TECHNICAL & SAFETY COMMITTEE
INTERNATIONAL PARACHUTING COMMISSION (FAI)

<p><i>Technical & Safety Information Notice No.</i></p>	<p>03/2010 W.N. 30</p>
<p><i>Date of Issue</i></p>	<p>09 August 2010</p>
<p><i>Subject Matter and Applicability</i></p>	<p>Note – The parachute systems in question are NOT sport parachuting rigs, but pilots’ rigs. This Information Notice is being disseminated to inform Riggers who may be asked to repack one of these systems, and as a general guide to Riggers to be aware of this issue if it should appear at a future stage with a sport parachute system.</p> <p>PARACHUTES AUSTRALIA 22 Bosci Rd, Ingleburn NSW 2565 Australia (PO Box 969) Ph: + 61 2 98295355 Fax: +61 2 98291300 Email: sales@parachutesaustralia.com</p> <p>SERVICE BULLETIN No PA SB1001 Issued 9th August 2010</p> <p>SUBJECT: THINBACK AND SLIMPACK 2 RIPCORD HOUSING CLAMP</p> <p>STATUS: MANDATORY</p> <p>IDENTIFICATION: Thinback Harness & Container System Part No. S005-() manufactured between July 2009 and June 2010 serial numbers: 5036, 5037, 5038, 5039, 5040, 5041, 5042, 5043, 5044, 5056, 5057, 5058, 5059, 5060, 5087, 5088, 5089 and 5096 Slimpack 2 Harness & Container System Part No. S003 manufactu

Image 1

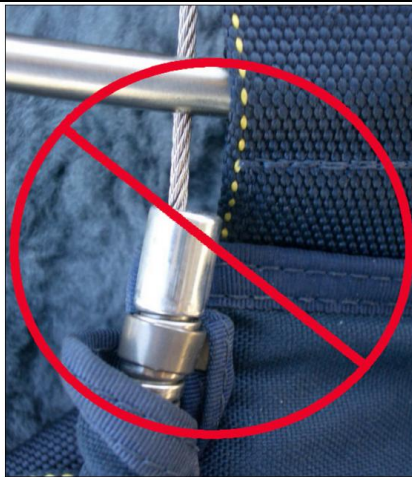
Thinback and Slimpack 2 harness and container systems contained within the above mentioned serial numbers that has a housing clamp installed “below” the housing end cap are to be removed from service and returned to the manufacturer for rectification.

Effected equipment to be returned to Parachutes Australia are to be sent by Registered Post to the above address. The registered post cost will be refunded to the sender upon return of the equipment.

Image 2

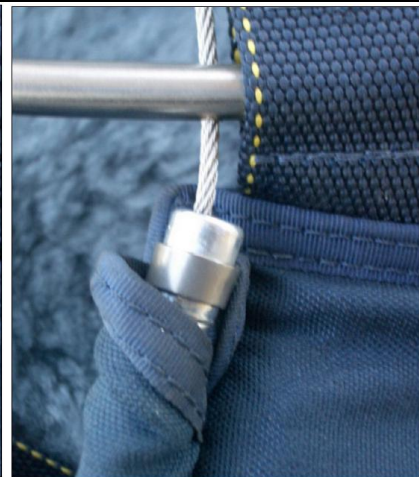
Thinback and Slimpack 2 harness and container systems contained within the above mentioned serial numbers that has a housing clamp installed on the housing end cap are unaffected and can remain in service.
